**MEMORANDUM****To: Matt Rasmussen****From: Timothy J. Thompson, P.G.  
Hiram Alba P.E., P.G.  
Daniel J. Brown, E.I.T.****Date: September 4, 2015****Subject: Review Response for Third Geological Review Matt Rasmussen Hillside Review  
6472 South Bybee Drive, Ogden, Utah, 84403 SA Project No. 15-140**

GeoStrata has received review questions of our report titled **Review Response for Geological Review – 6472 and 6498 South Bybee Drive, Weber County Parcel Numbers: 07-753-0001 and 07-753-0002 Uintah, Weber County, Utah, SA Project Number 15-140**, GeoStrata Job Number 910-001 and dated July 9, 2015. This report was prepared for Mr. Matt Rasmussen and submitted to Weber County for review. Mr. David B. Simon, P.G. of Simon Associates LLC (SA) prepared a review of our report. This memorandum was prepared in response to a series of review questions presented in a letter prepared by Mr. Simon and dated May 27, 2015.

**Plate  
1**

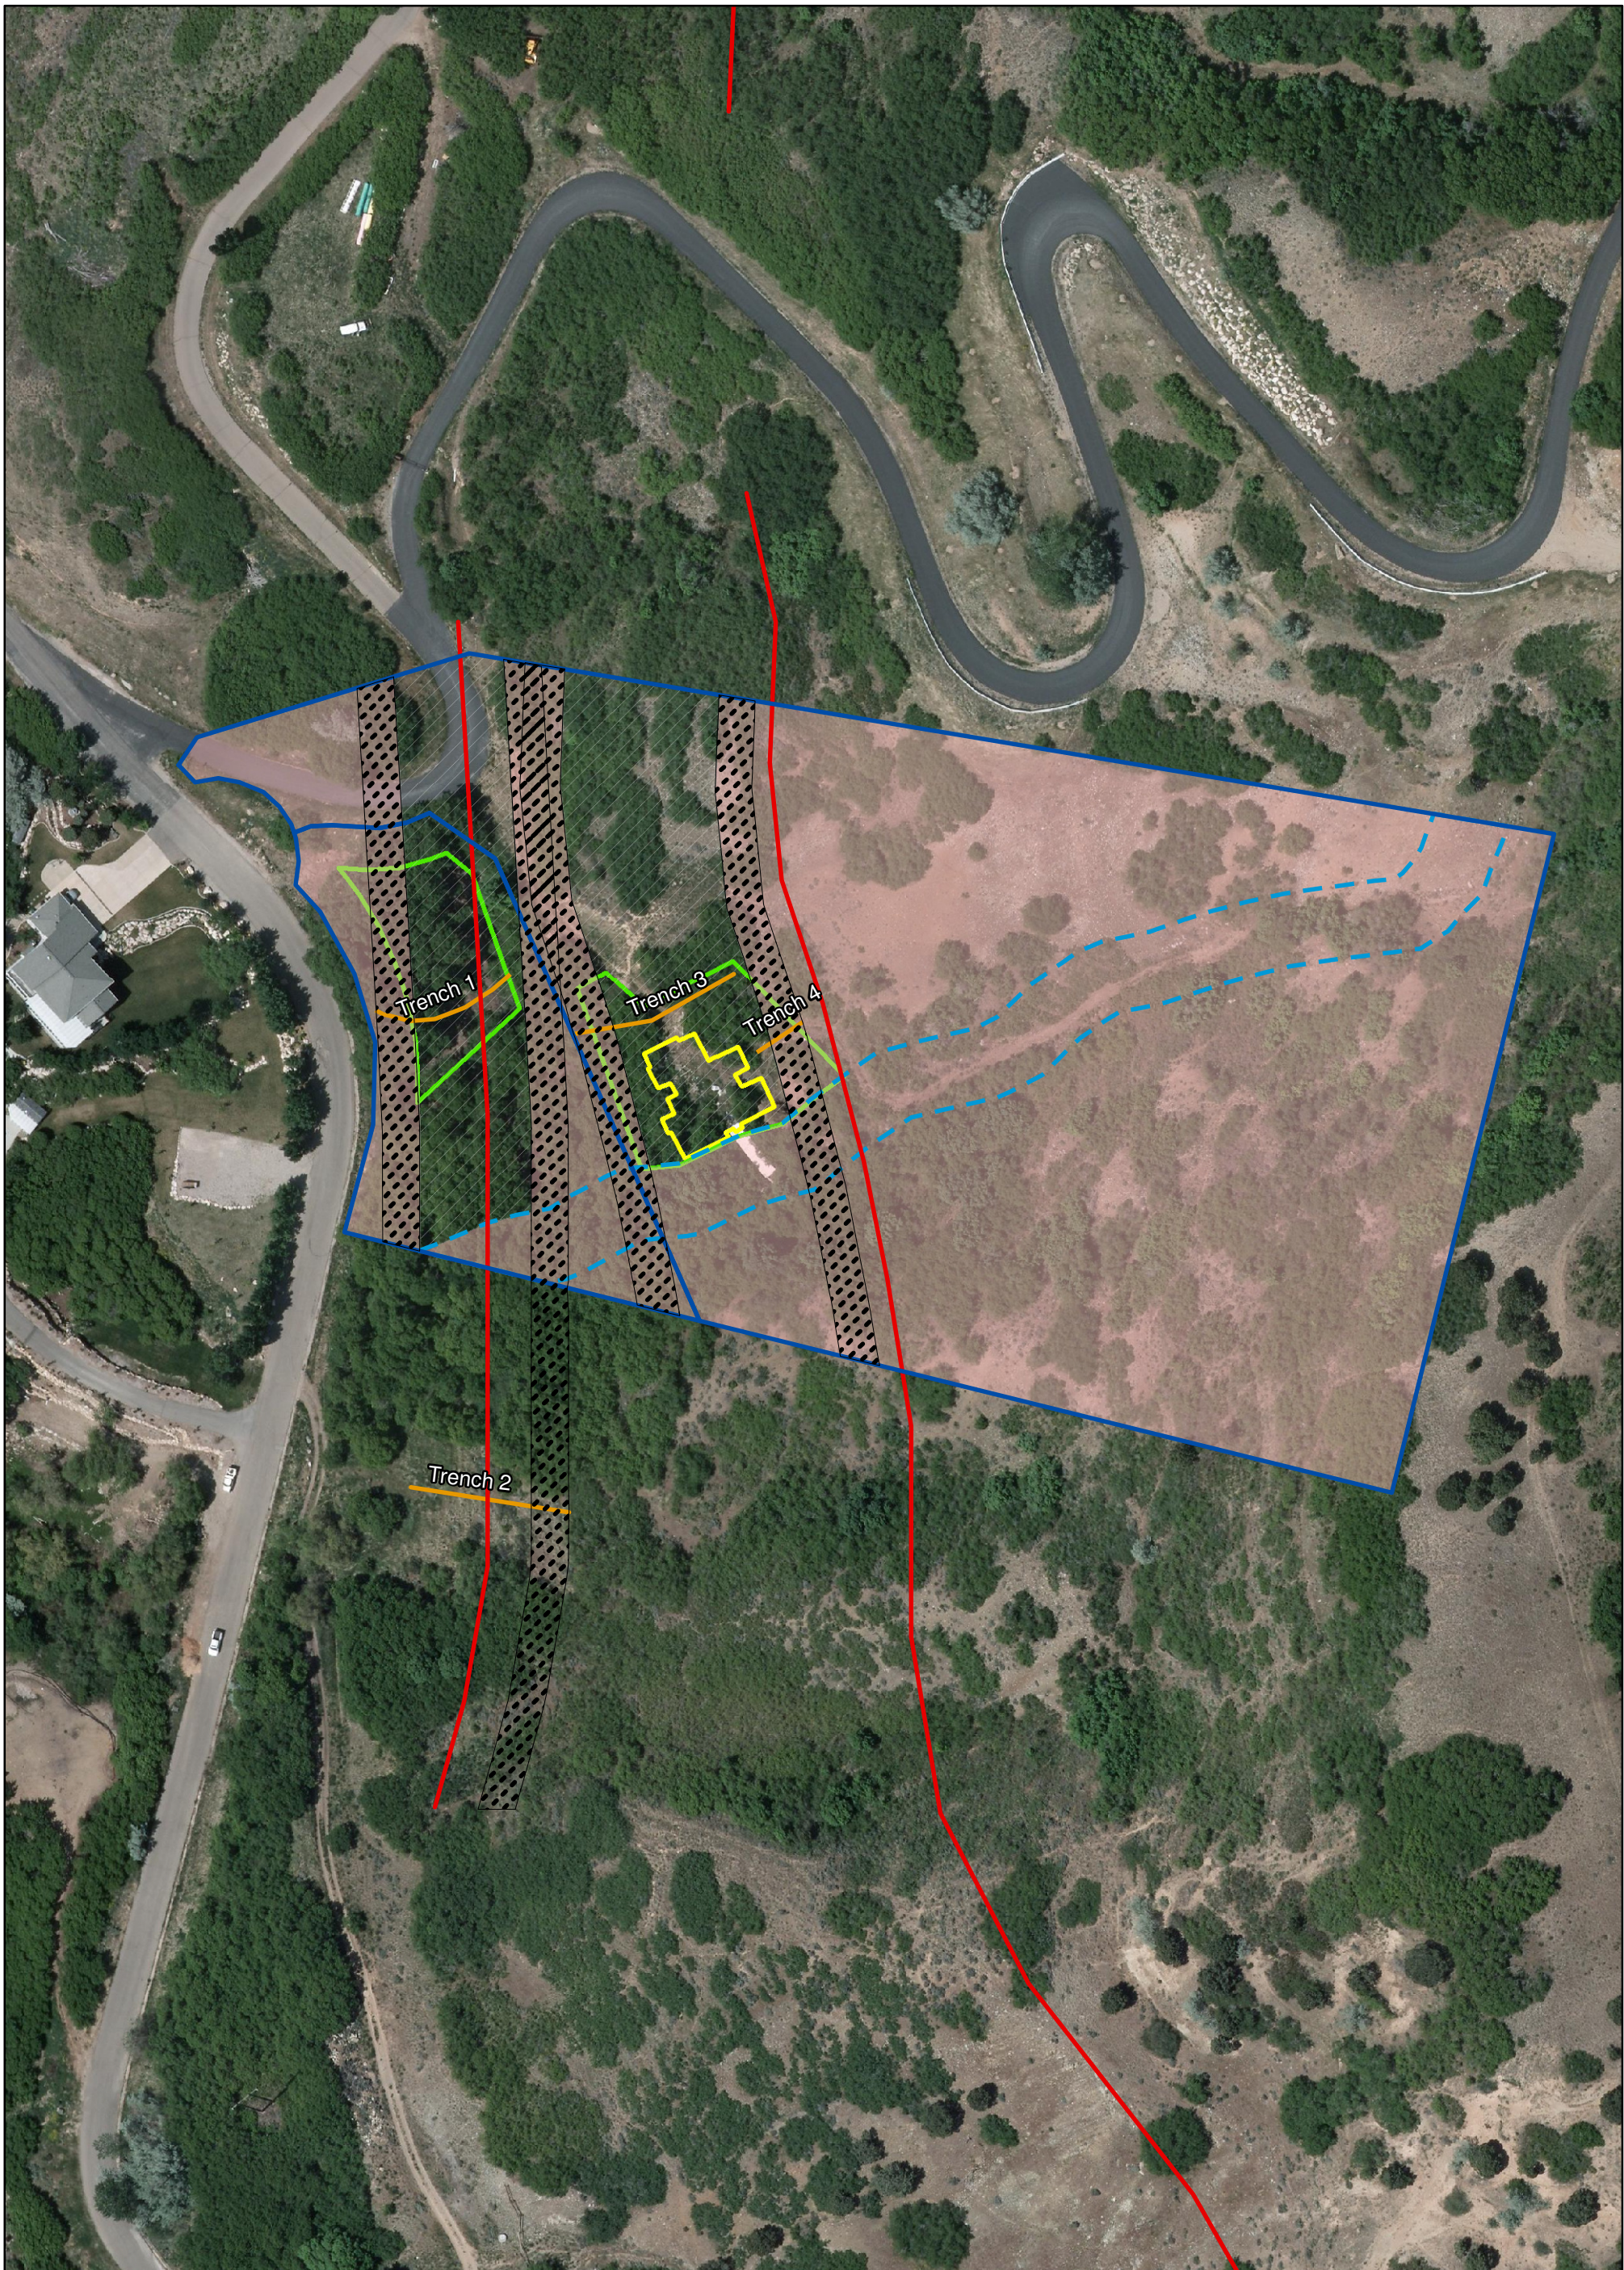
*There appears to be an inconsistency between the calculated drainage setback as shown on GeoStrata Plate A-6, Site Geologic Setback Map (attached), and site geologic conditions as shown on GeoStrata Plate A-5, Site Geologic Map (attached). Plate A-6 depicts the drainage setback coinciding with the proposed building foot print, northwest of the drainage setback line. SA recommends Weber County request GeoStrata clarify the apparent discrepancy.*

GeoStrata has revised the Site Geologic Setback Map to more accurately reflect the location of the drainage easement delineated in the Grading/Drainage Plan prepared by Silverpeak Engineering. The updated map is attached as Plate 1.
